ED-MONITOR-116C

PCN

by EDA Technology Co., Ltd

1 Product Change Notice 1

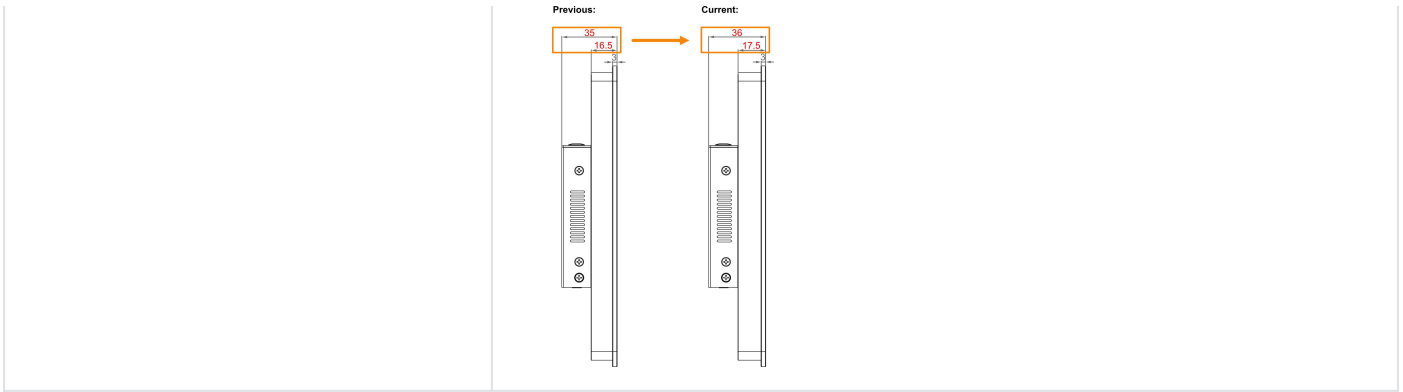
Changes	Results
LCD bezel thickness increased by 1mm	We have optimized the LCD bezel structure to provide additional clearance for internal cable routing. - LCD bezel thickness: adjusted from 16.5mm to 17.5mm. - Total product thickness: correspondingly adjusted from 35mm to 36mm.
